**Subject: Bid Package #2**  
Abbott Middle School HVAC Replcmt-DSA 01-119556  
George Hall Elementary School HVAC Replcmt-DSA 01 119523  
Laurel Elementary School HVAC Replcmt DSA 01-119551  
**San Mateo - Foster City School District**

**ADDENDUM NO. 1**

**Subject:** Abbott Middle School HVAC Replacement  
San Mateo - Foster City School District  
Aedis Project No. 2021005.06  
DSA Application #01-119556

### ADDENDUM NO. 1

6 ROUND DUCT HANGER AT CONCRETE CEILING

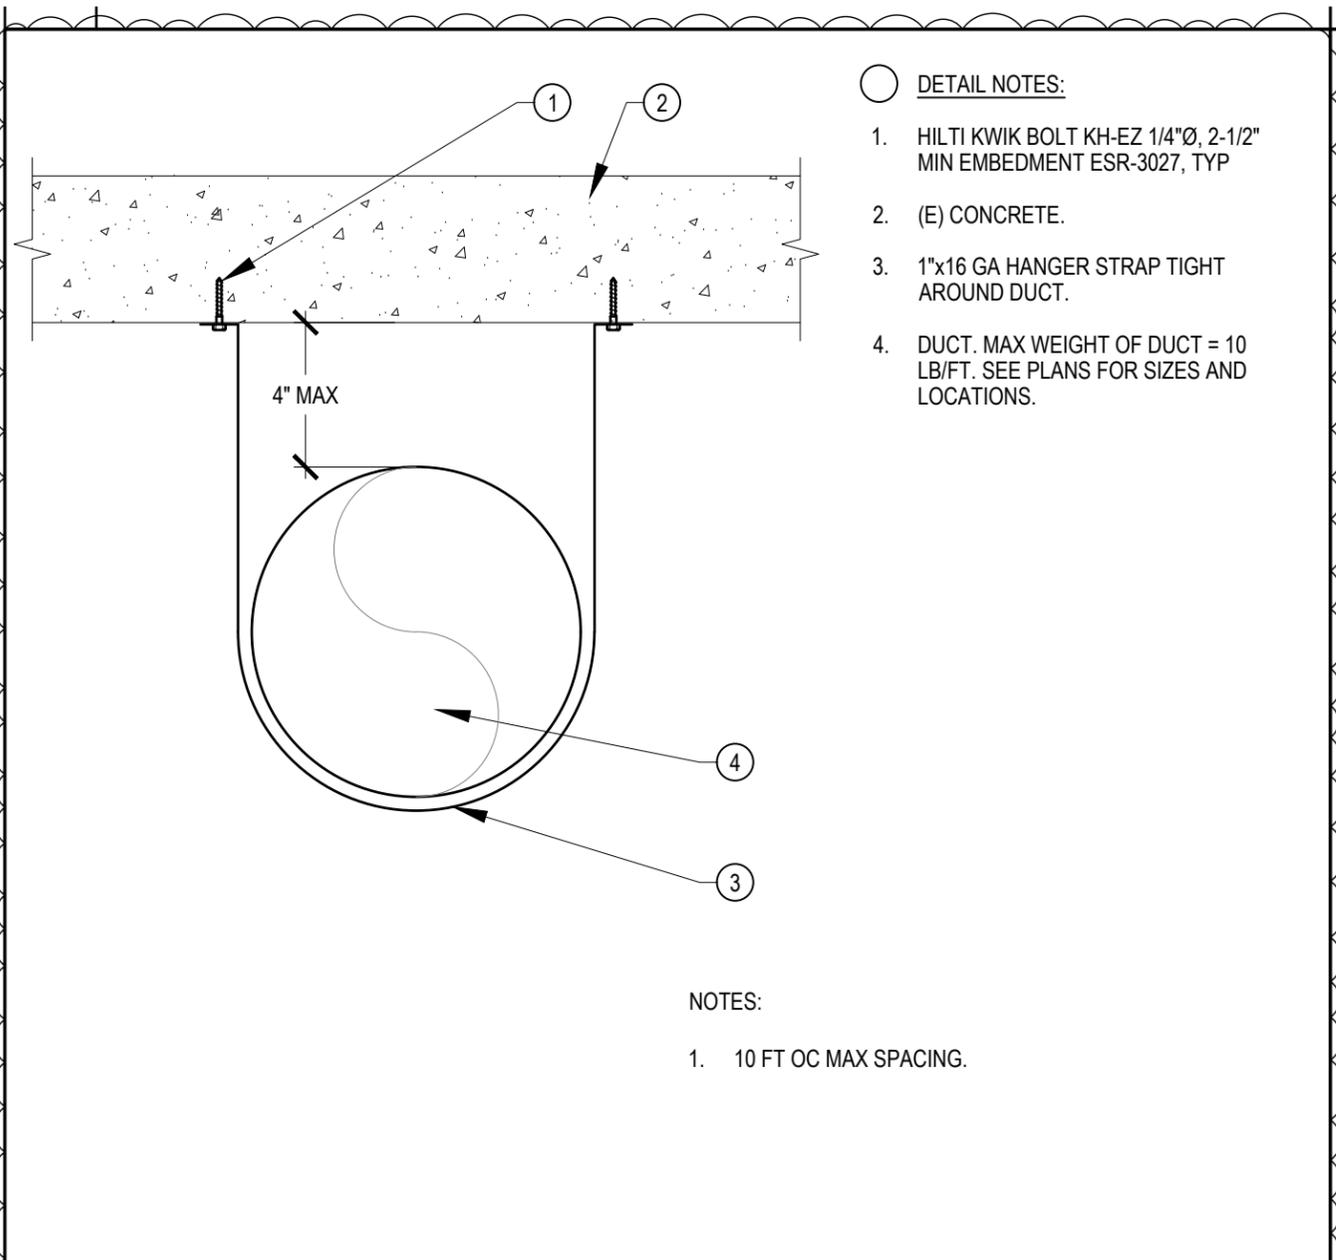
ITEM NO. 1.24: DRAWING SHEET MP6.02 – DETAILS – MECHANICAL & PLUMBING

Add: Detail 6 per AD1-MP6.02

**1 ELECTRICAL SITE PLAN**  
E1.1 SCALE: 1" = 40'-0"

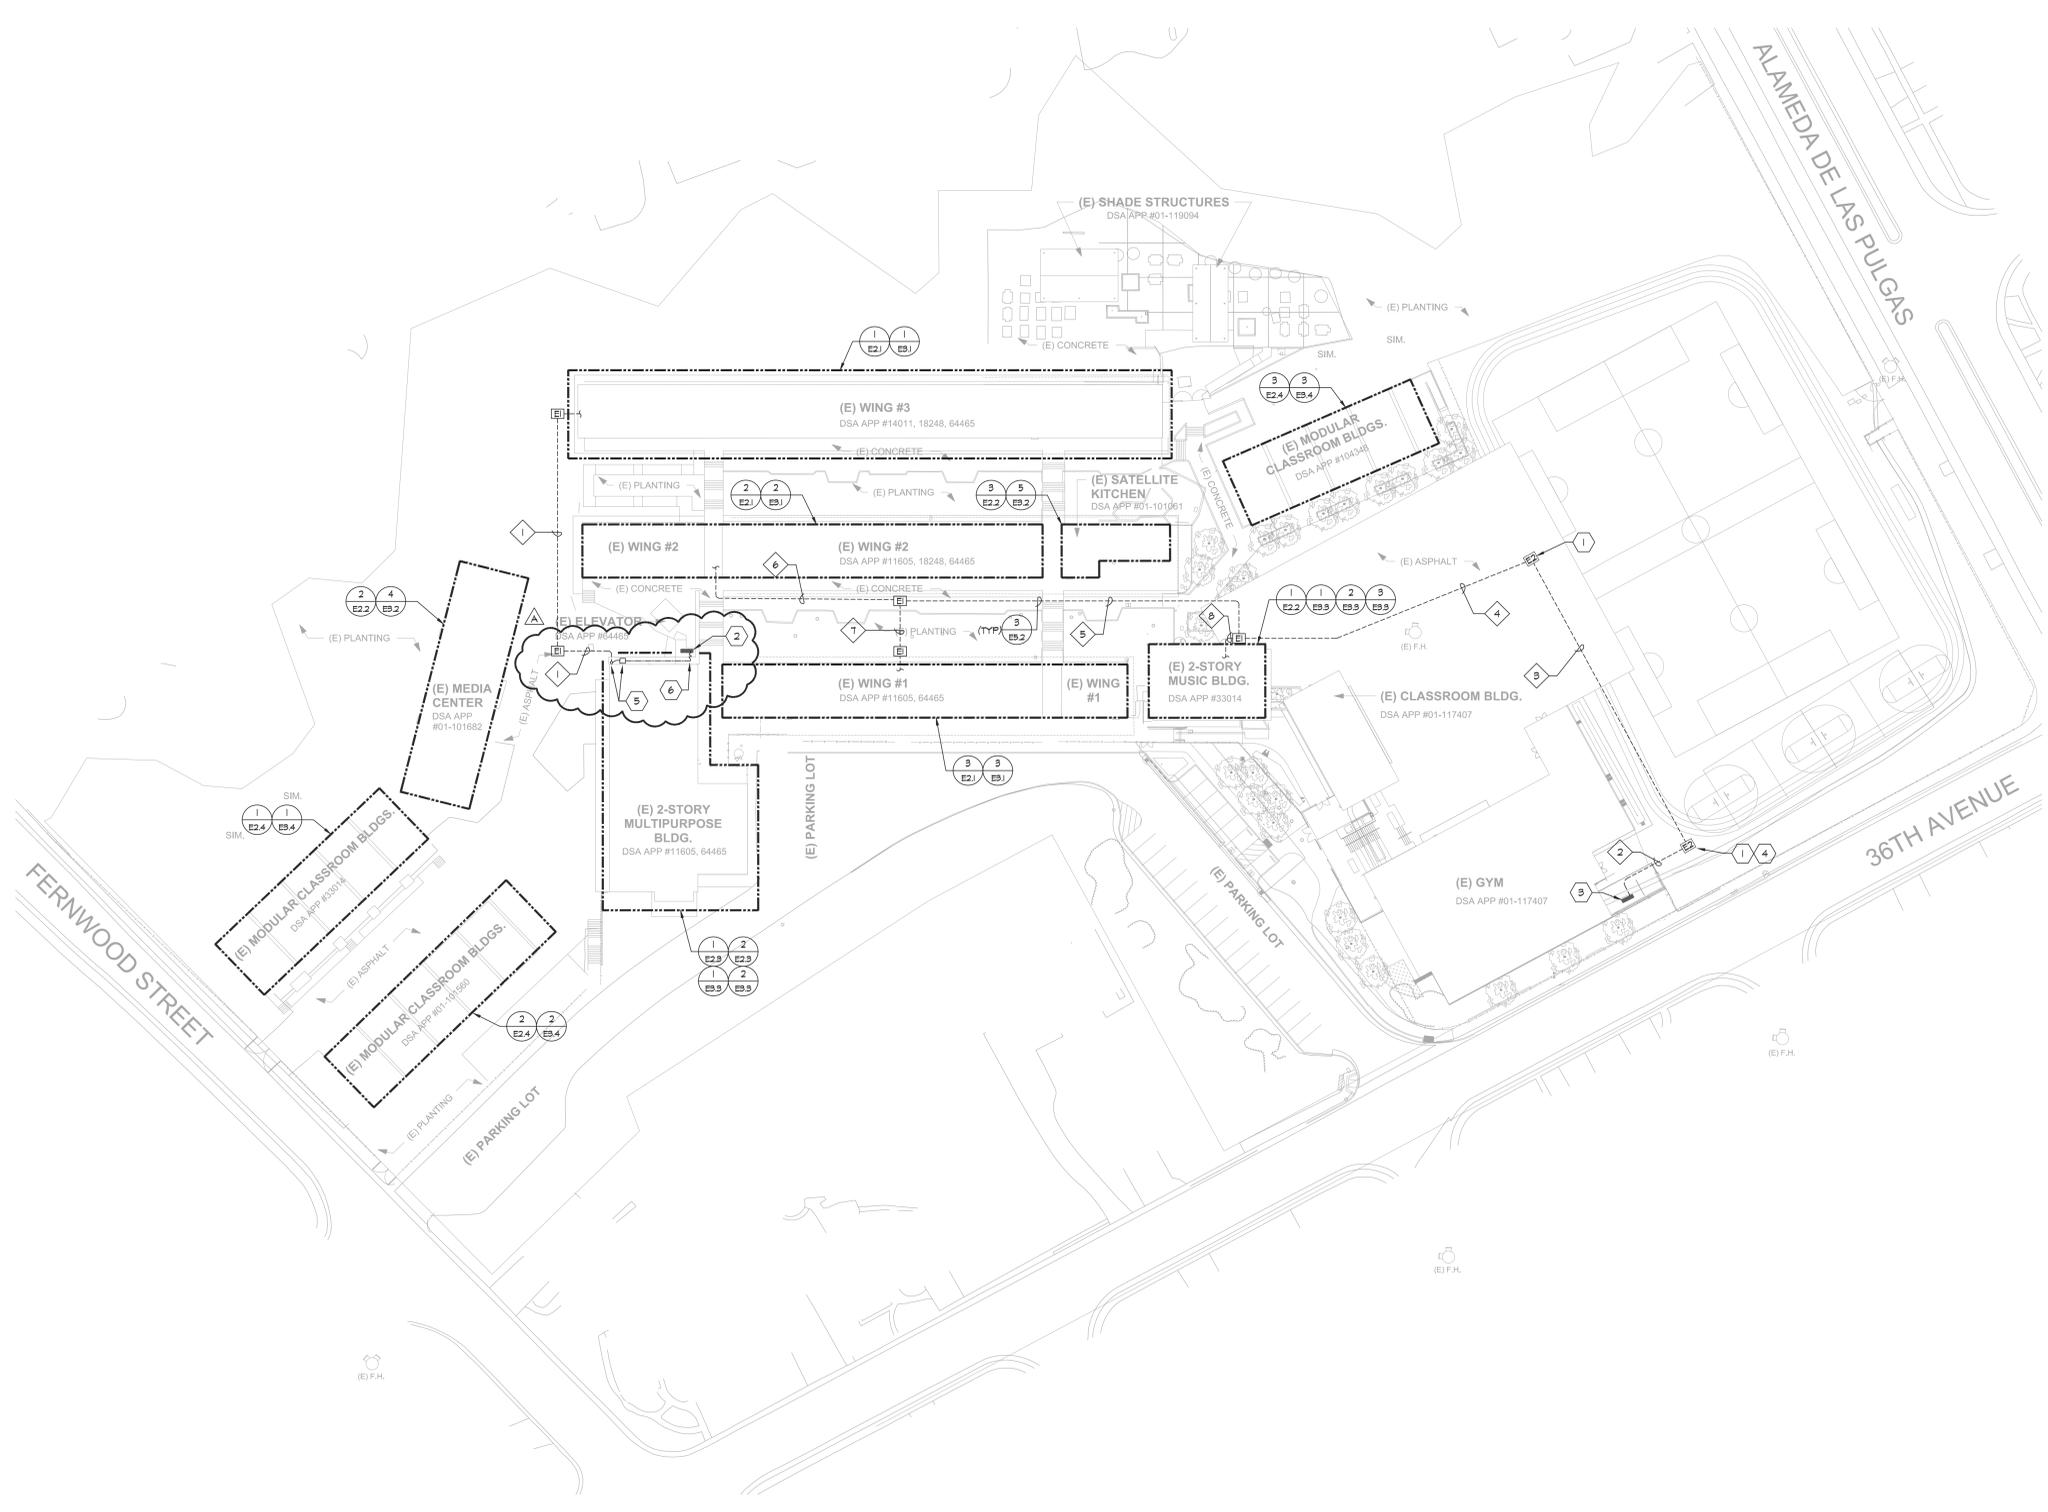
ITEM NO. 1.25: DRAWING SHEET E1.1 – ELECTRICAL SITE PLAN

Revise: Site Plan layout at 2-Story Multipurpose Bldg. per AD1-E1.1.

Revise: Sheet Note #5 and #6 per AD1-E1.1.

DATE 11/24/2021  
 JOB # 2021005.06  
 SHEET # AD-1  
**E3.1**

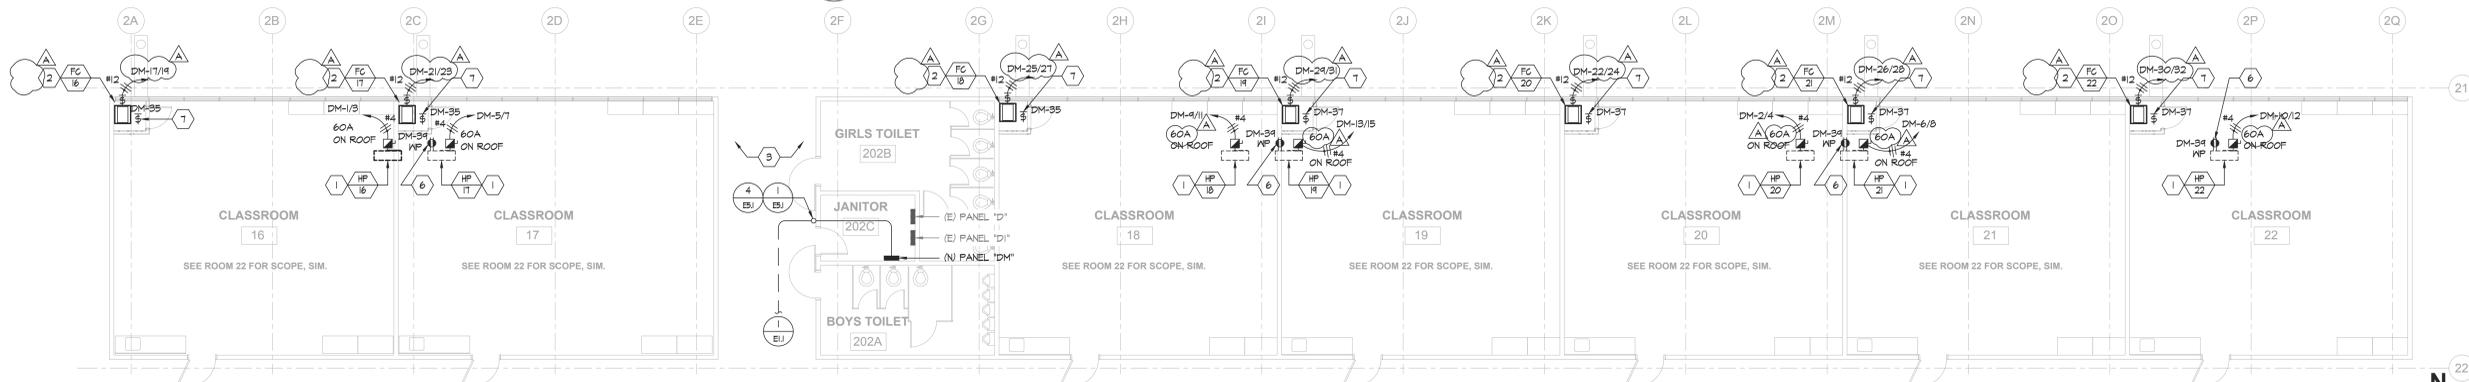
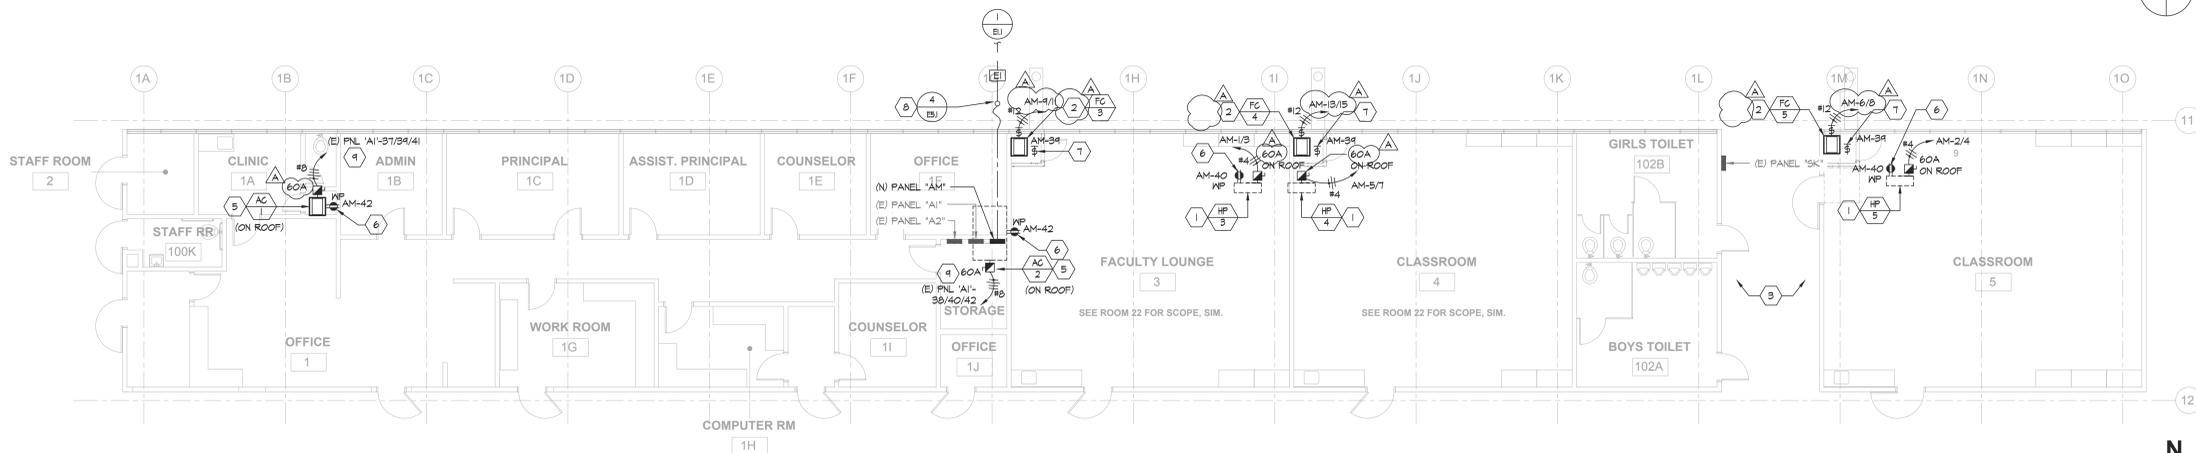
ITEM NO. 1.26: DRAWING SHEET E3.1 – ELECTRICAL NEW FLOOR PLANS – WINGS 1, 2 & 3

Revise: Electrical plan 1/E3.1, 2/E3.1 & 3/E3.31per AD1-E3.1

Revise: Sheet Noters #1, #2 & #4 per AD1-E3.1

Omit: Sheet Noters #4 per AD1-E3.1

DATE **11/24/2021**  
JOB # **2021005.02**  
SHEET # **AD1-  
A1.02**

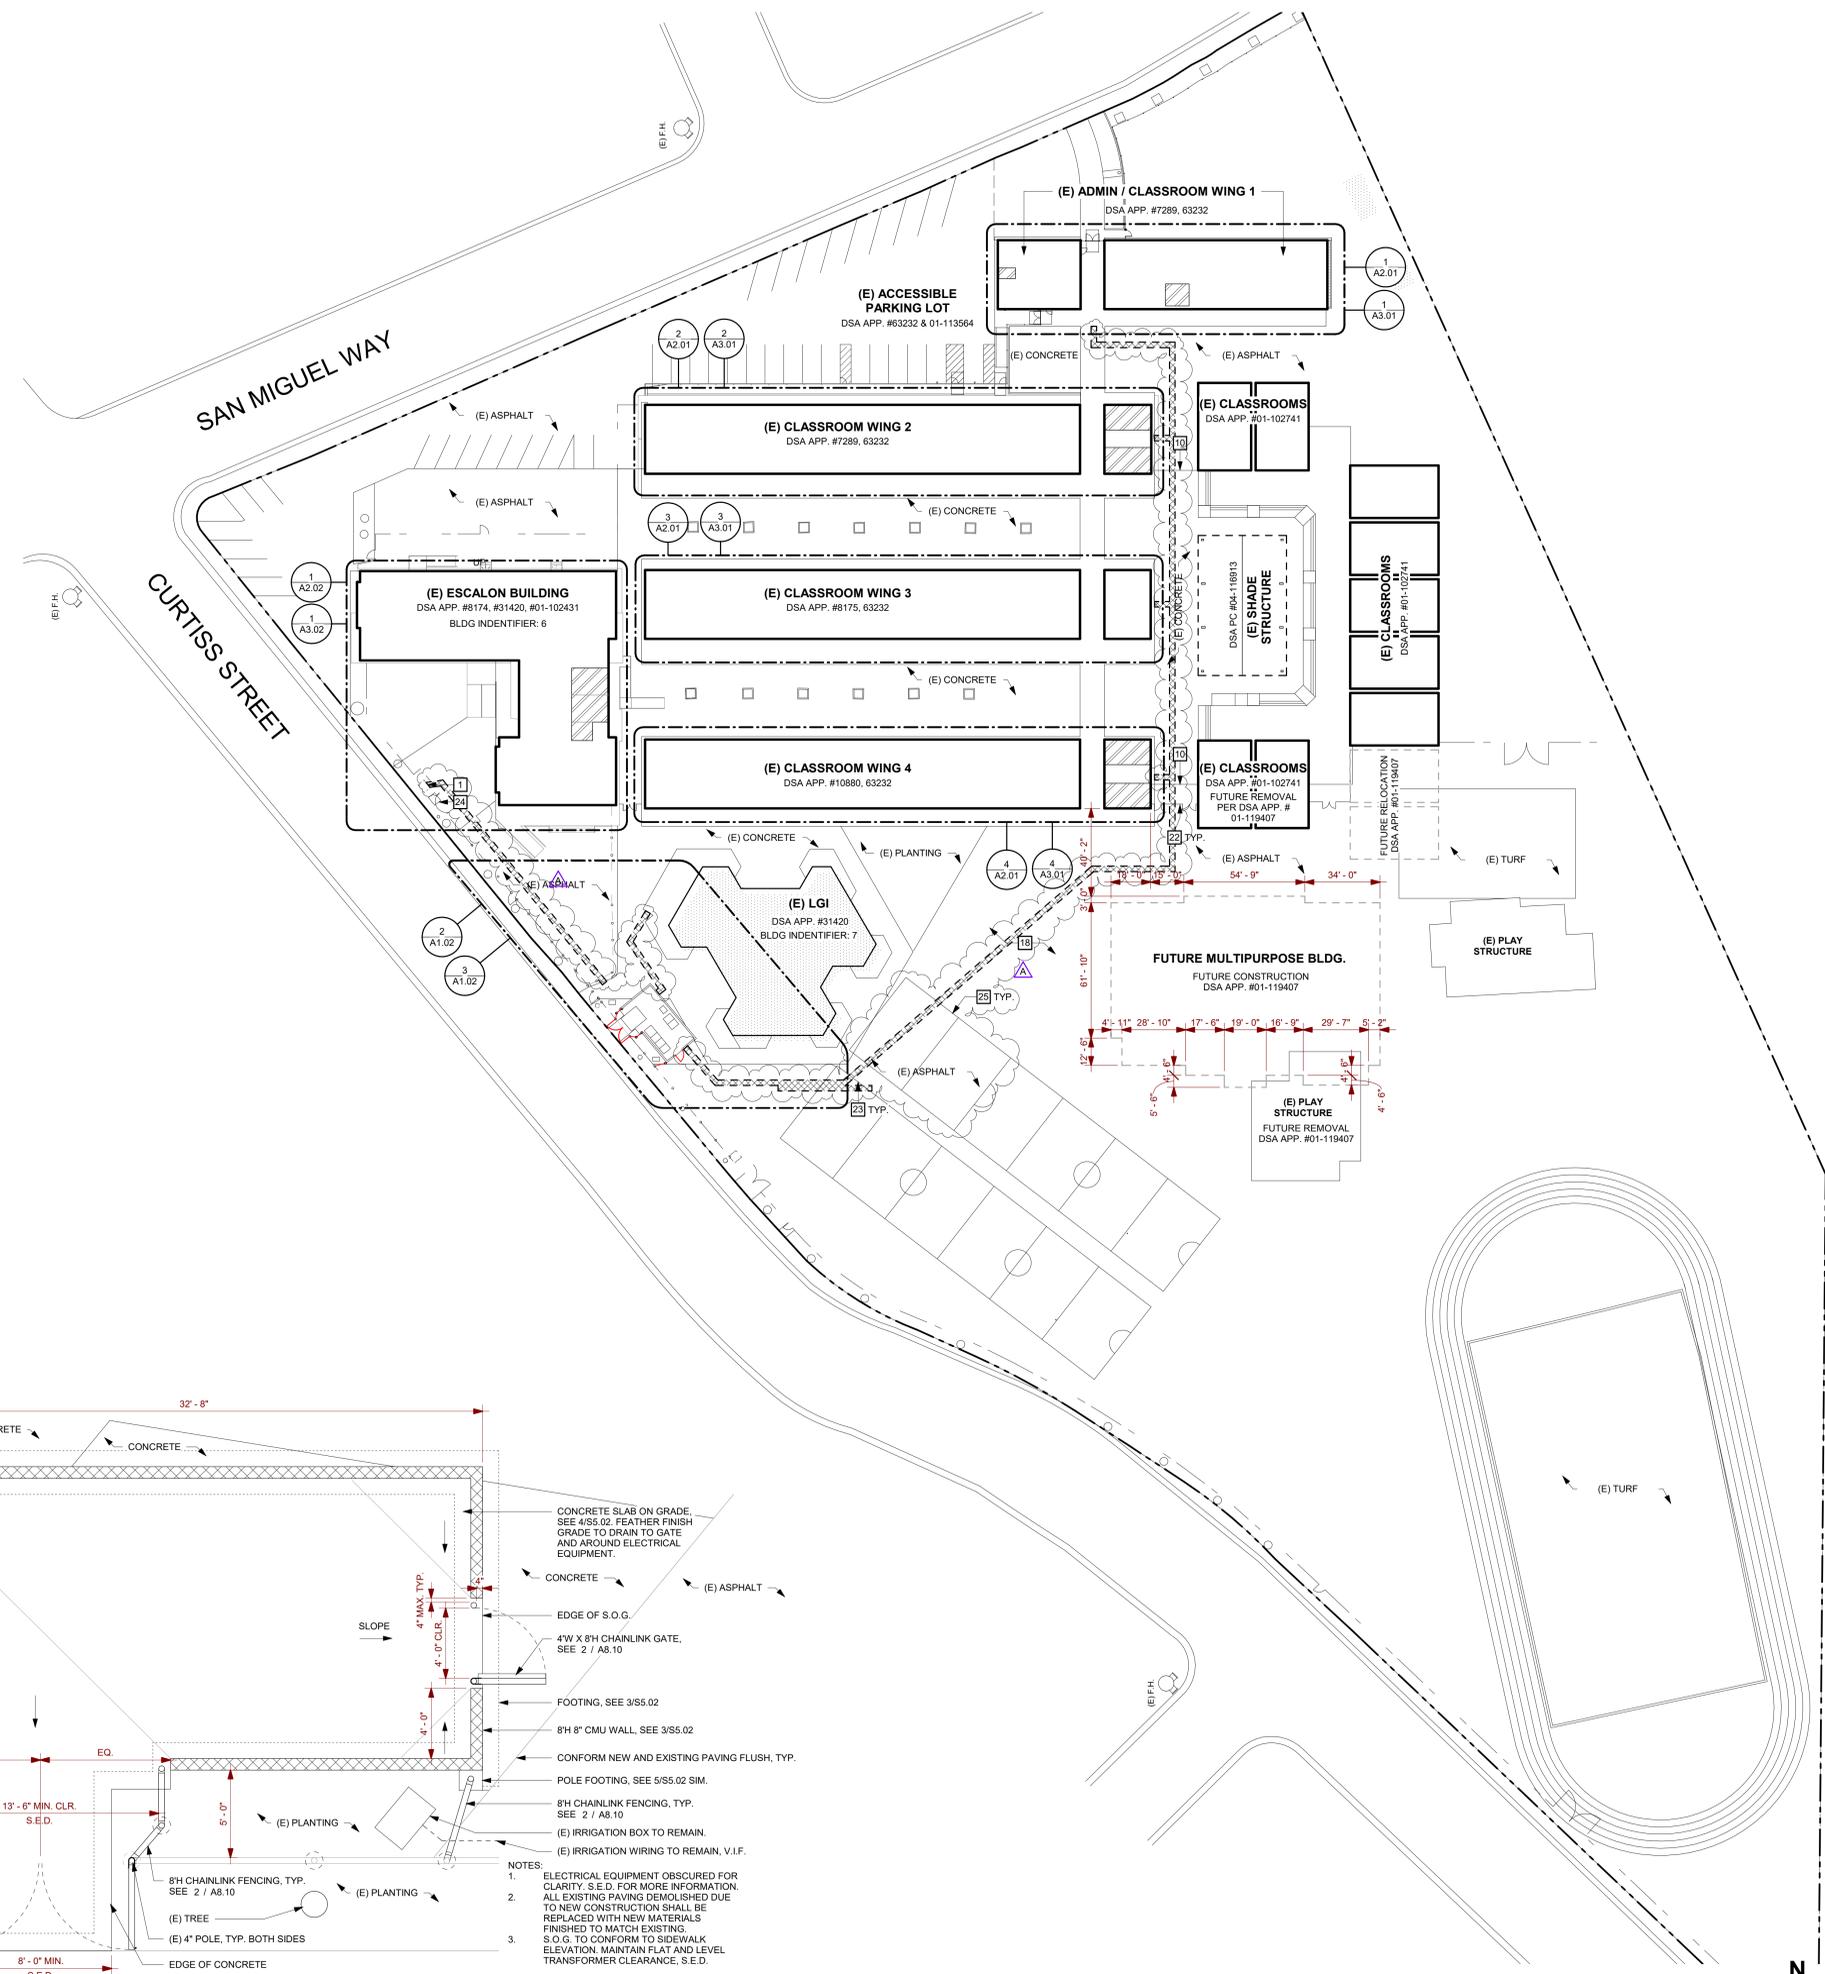
ITEM NO. 1.5: DRAWING SHEET A1.02 – DEMOLITION & NEW SITE PLAN

- Add: Trench area to New Site Plan 1/A1.02 & Graphic Key per AD1-A1.02
- Add: General Sheet Note item G per AD1-A1.02
- Add: Striping keynote 25 to New Site Plan 1/A1.02 per AD1-A1.02
